PLAN COMMISSION MEETING NOTICE AND AGENDA

Thursday, March 21, 2019

REPORT TO THE PLAN COMMISSION

Project Name: KD Glass rezoning, Certified Survey Map and Site & Building Plans

CERTIFIED SURVEY MAP NO. _____

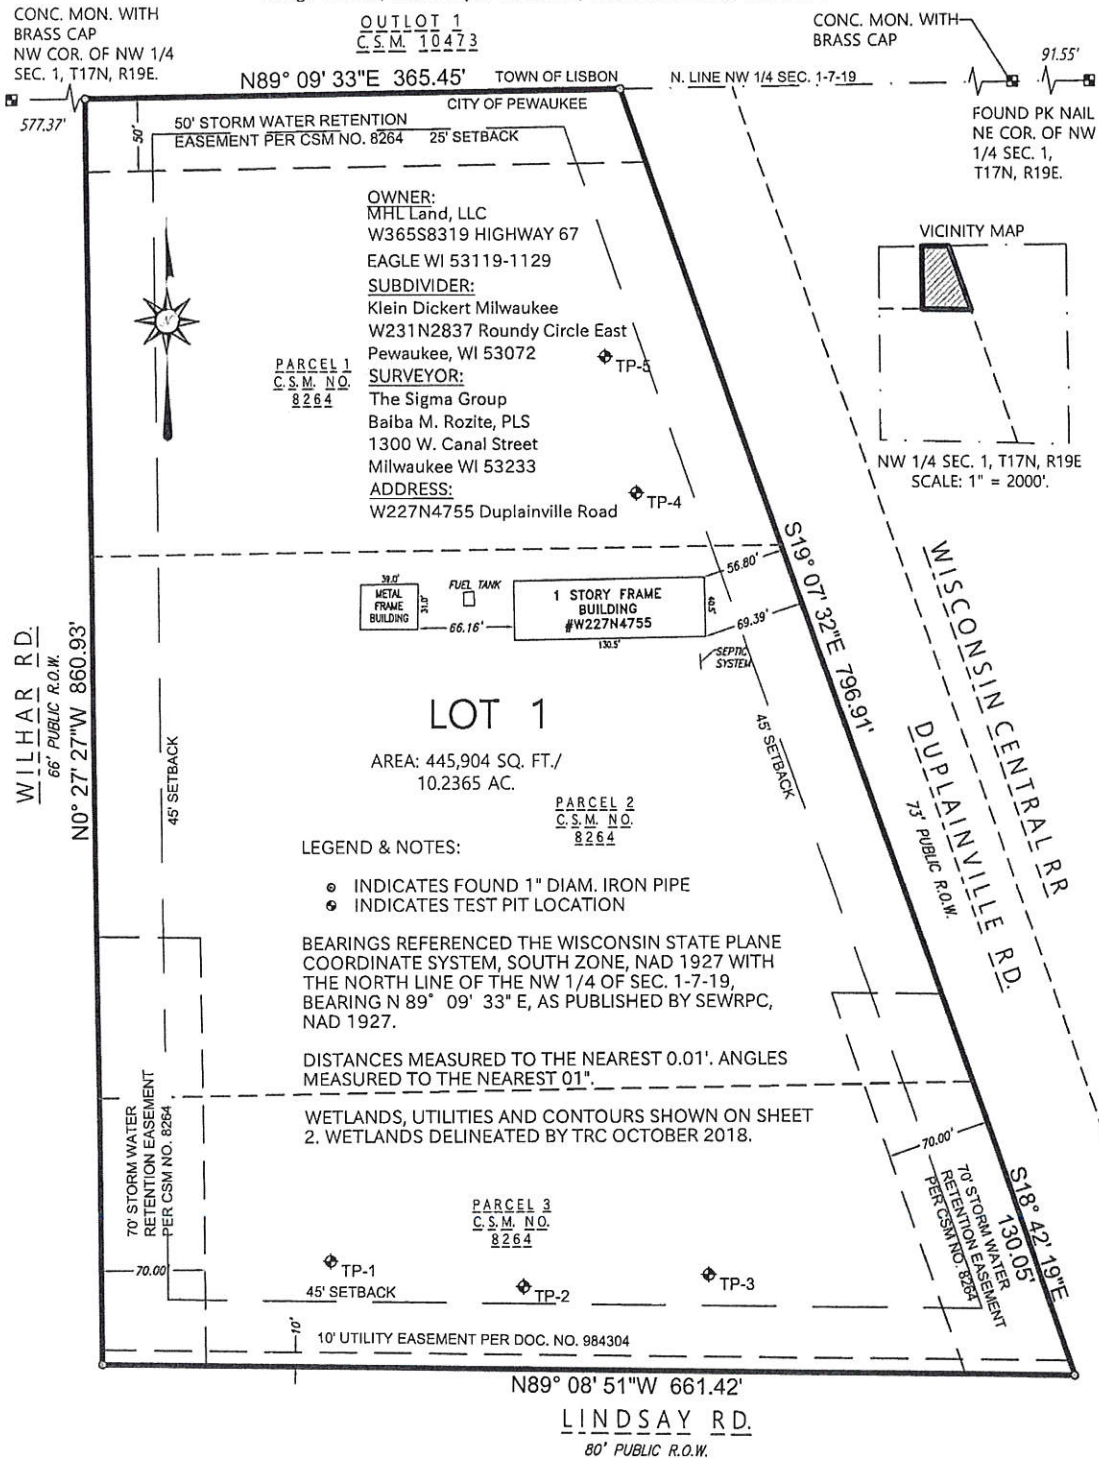
The CSM combines the three existing parcels into a single lot. Staff is recommending the following conditions be met to the satisfaction of the City Planner and prior to recording the CSM with the Waukesha County Register of Deeds:

- Per Section 18.0602, the proposed lot lines to be removed shall be labeled as “previous lot line – to be removed.”
- The following information shall be shown on the face of the CSM as required by Section 18.0603b:
 - Setbacks or Building Setback Lines required by the Plan Commission or other City or County Ordinances;
 - Utility, drainage, and access easements; and
 - Date of the CSM.
- A 30-foot wide planting easement shall be illustrated along the south property line per Section 18.0401m(2). The easement shall include a note requiring that the easement be reserved for the planting of trees and shrubs, and the building of structures within the easement is prohibited.
- The Plan Commission Secretary name shall be revised to Brandon Bergman, Secretary.

CSM No. 8264 states that the storm water easements are intended for retention basins. The proposed development plan includes improvements within the north easement (to be released as conditioned above) and parking and drives within the easement located at the southwest corner of the property (recommended to remain). Staff questions whether any development should occur within these easements other than those improvements related to storm water retention.

As such, staff recommends that the 70-foot wide storm water retention easement be revised to locate all parking and drive areas outside of the easement, prior to recording the Certified Survey Map with the Waukesha County Register of Deeds. This would shorten the length of the easement by approximately 40-feet.

SITE PLAN
SCALE: 1" = 40'-0"

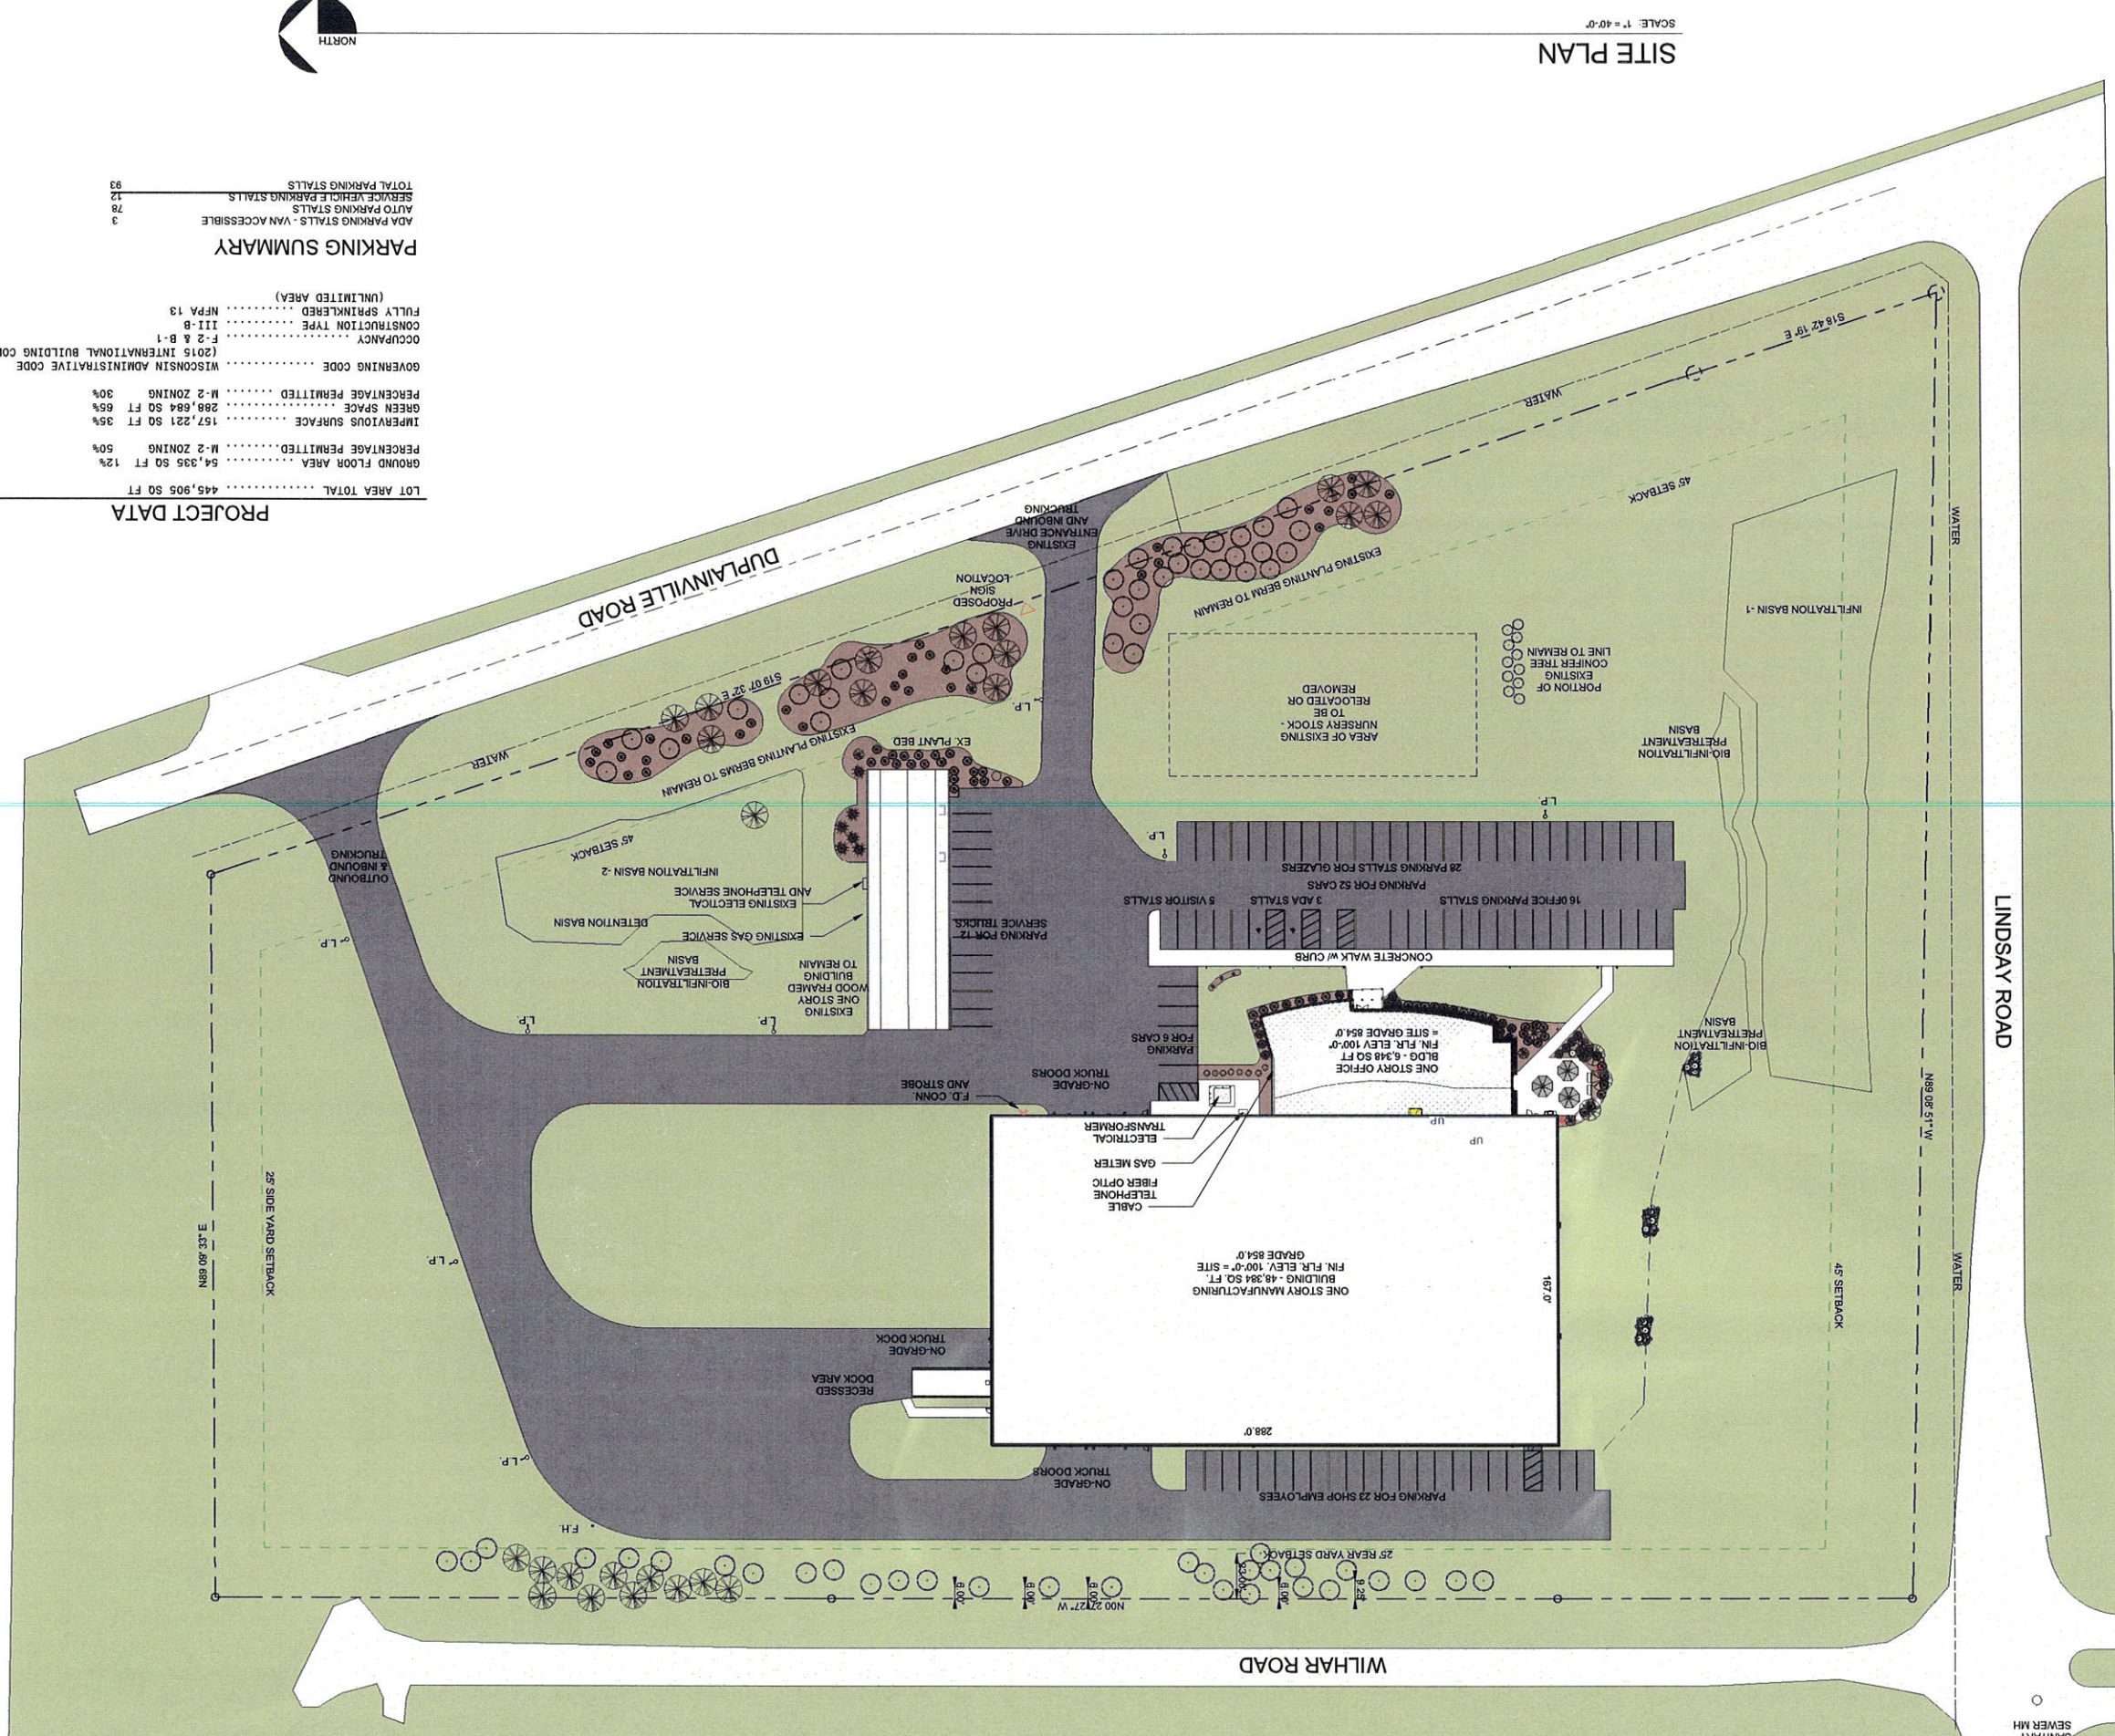
The site plan includes 82 parking spaces, including 3 ADA accessible spaces. This equates to a parking ratio of approximately 1.5 parking spaces per 1,000 square feet of gross floor area. The Zoning Code, as a guideline, suggests one space per two employees in a 12 hour period. With 40 employees, 20 parking spaces would be suggested.

Staff has indicated to the applicant that dumpsters, loading areas and truck docks must be screened. In addition, a 30-foot landscape easement along the south property line is recommended on the CSM, and staff noted that particular attention be made within this area to provide a buffer to the existing single-family residential development to the south.

CERTIFIED SURVEY MAP NO. _____

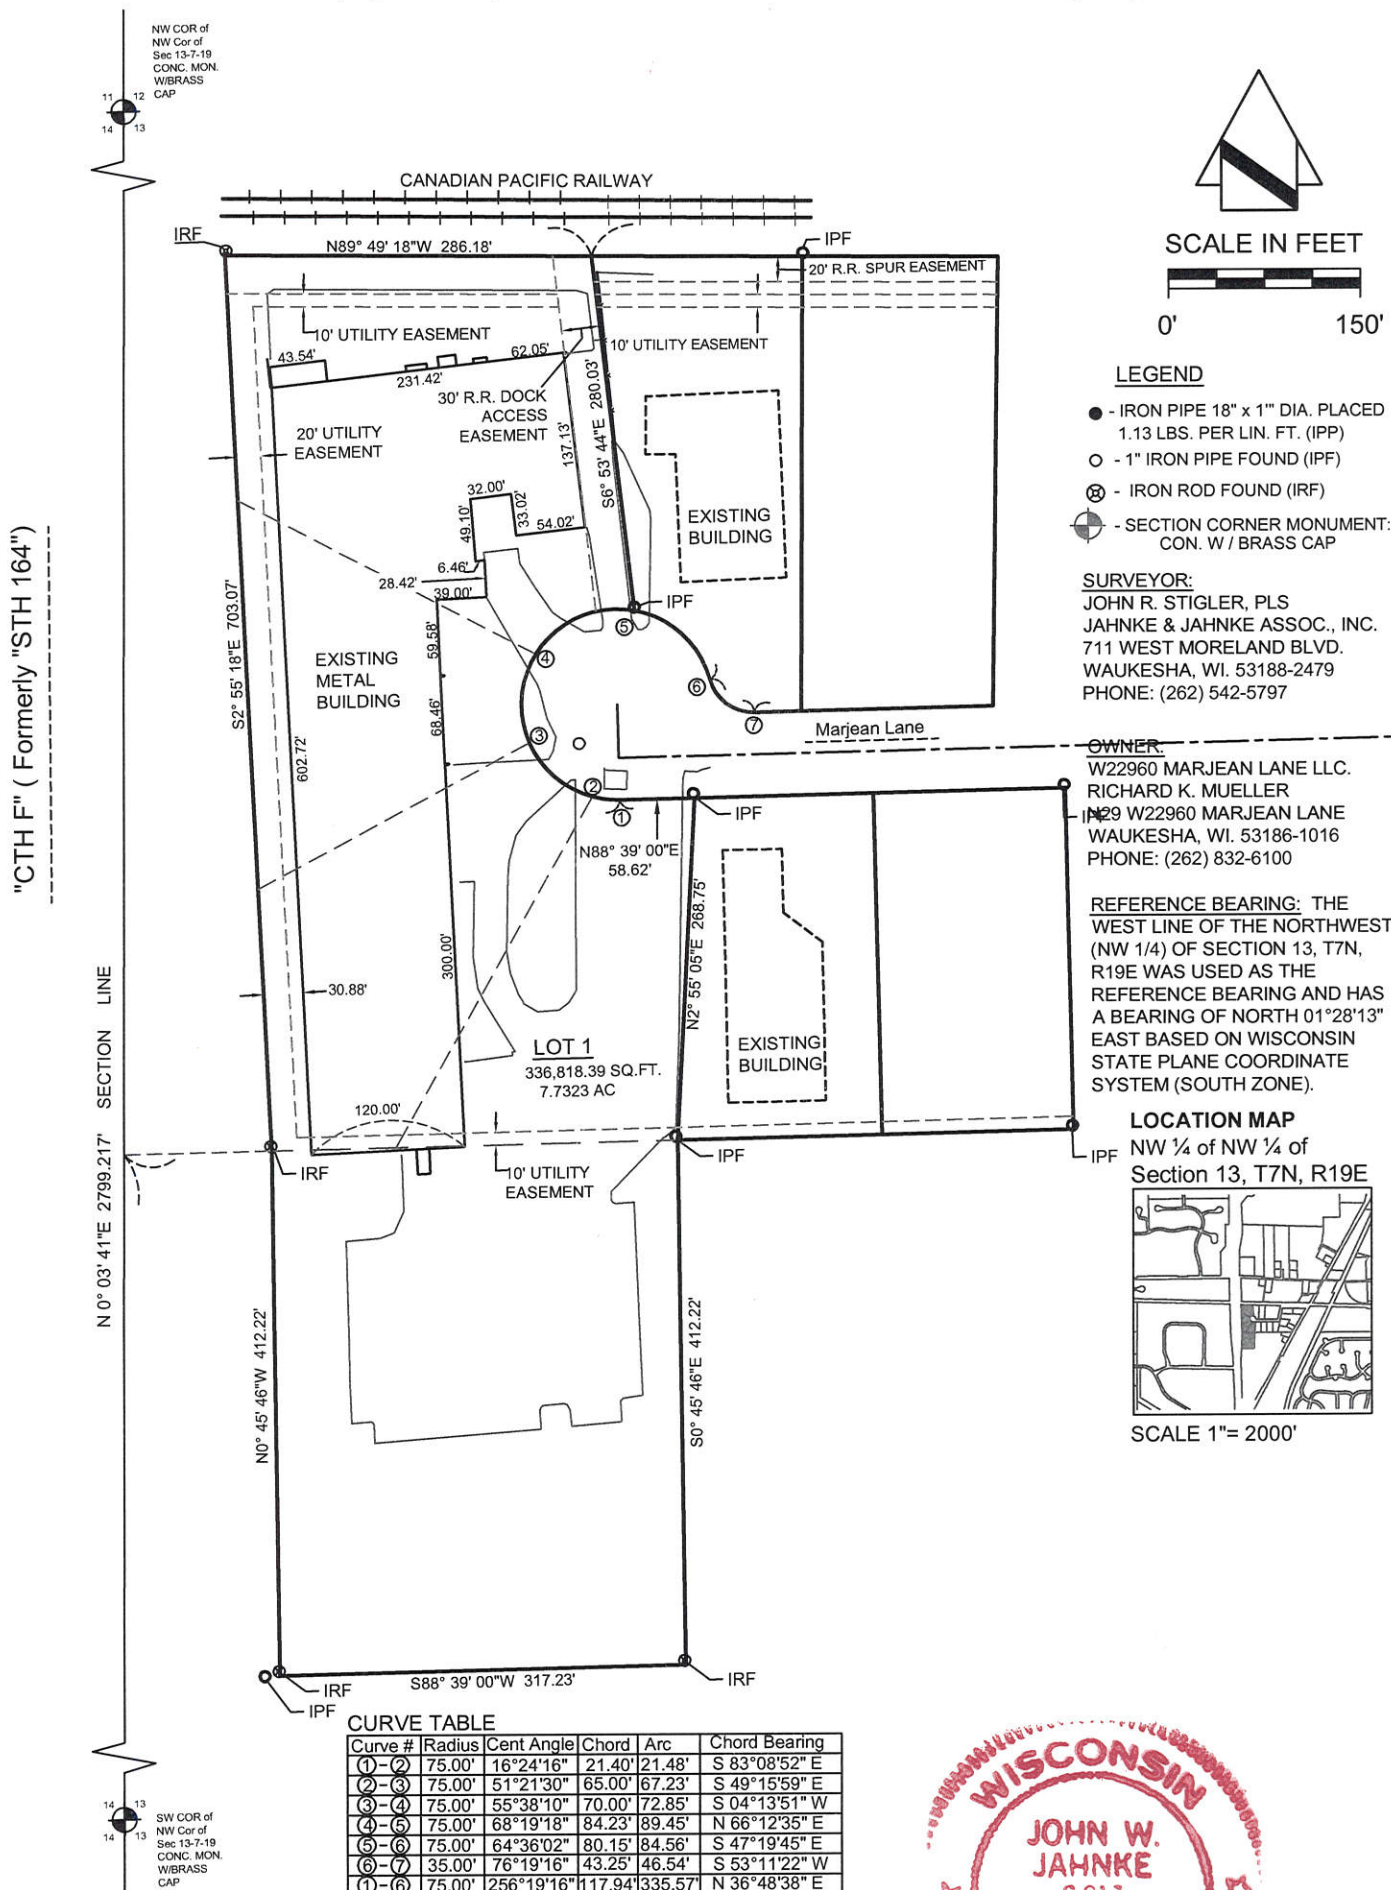
A motion recommending approval of a 1 Lot Certified Survey Map combining the five existing properties located at approximately N29W22960 Marjean Lane, bearing Tax Key Nos. 0914008, 0914007, 0914006, 0914005 and 0914973001, subject to the following conditions being met to the satisfaction of the City Planner and prior to recording the CSM with the Waukesha County Register of Deeds:

2. The following information shall be shown on the face of the CSM as required by Section 18.0603b:
 - a. Setbacks or Building Setback Lines required by the Plan Commission or other City or County Ordinances;
 - b. A Required Preliminary CSM shall include existing and proposed contours as set forth in Section 18.0601
3. The Plan Commission secretary name shall be corrected to Brandon Bergman, Secretary.
4. Properties not being created by the CSM shall be outlined in a lighter dashed line, opposed to a bold line matching the Lot 1 boundary. Specifically these adjacent lots must be identified as Lot 3, 4, 9 and 10 of the R & D Industrial Park subdivision plat.
5. The owner address shall be relocated on Sheet 1 to not overlap with “IPF.”
